Product Change Notice (PCN)

PCN Number: PCN-0384612R-01

Product(s) Affected: CMS-18138A-SP

Previous:

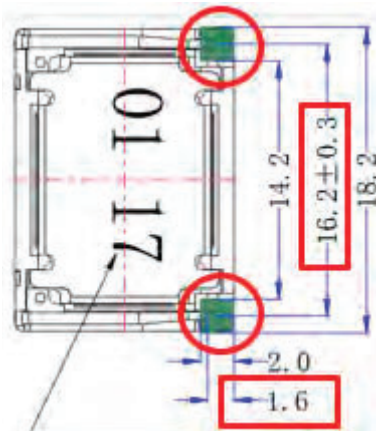
Description of Change: Spring contacts replaced. PCB layout unchanged.

Pin Pitch- 16.2 ± 0.3 mm
 Touching point- 1.6 ± 0.2 mm

New:

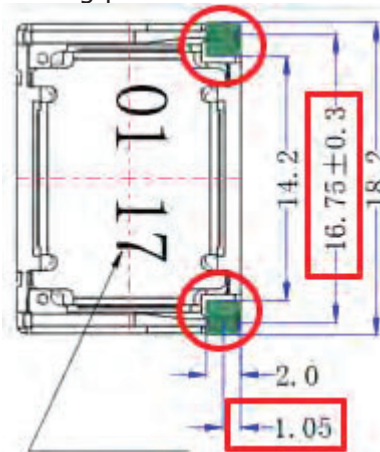
Pin Pitch- 16.75 ± 0.3 mm
 Touching point- 1.5 ± 0.2 mm
